DOCUMENT CHANGE REQUEST

DCR number	558	Changes required for:	N/A	Originator:	Olivier Masson
Date:	2009/12/02	Date sent:	2009/12/02	Organisation:	CNES
Status:	IMPLEMENTED

Title:	Accessories for Connectors Microminiature 3401/029, 3401/077 and Connector Savers 3401/041				
--------	--	--	--	--	--

Number:	3401/032	Issue:	3
---------	----------	--------	---

Variant 10 - Screwlock Assembly for Connector Savers

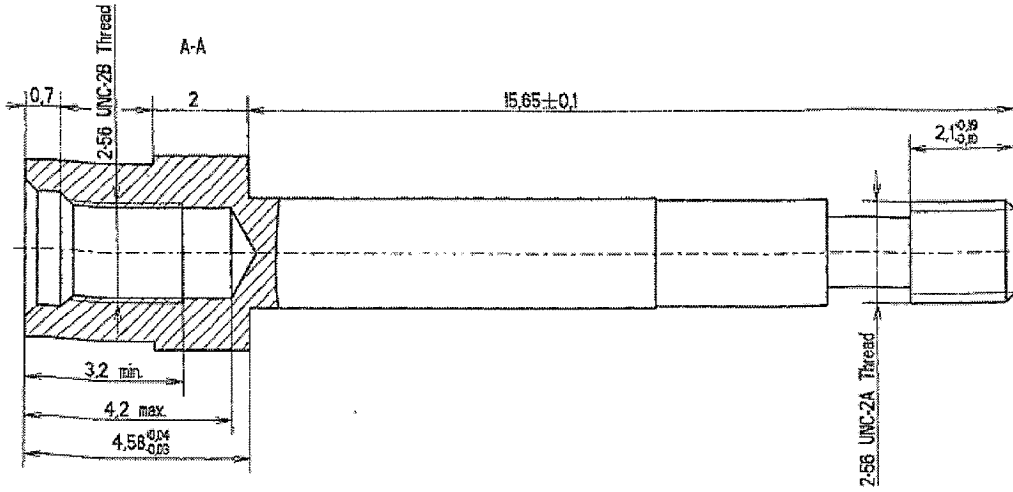
Page 10 : representation of the screwlock to be modified as shown in the attached document.

No word changing, only diameter of the screwlock added on the picture and 2 diameters very similar replaced by a single one.

Design modification and simplification
Current representation with 2 diameters very similar and no value specified is replaced by a single diameter of 2.13 mini.
Modification submitted to O. Perat and approved (see attached e-mail)
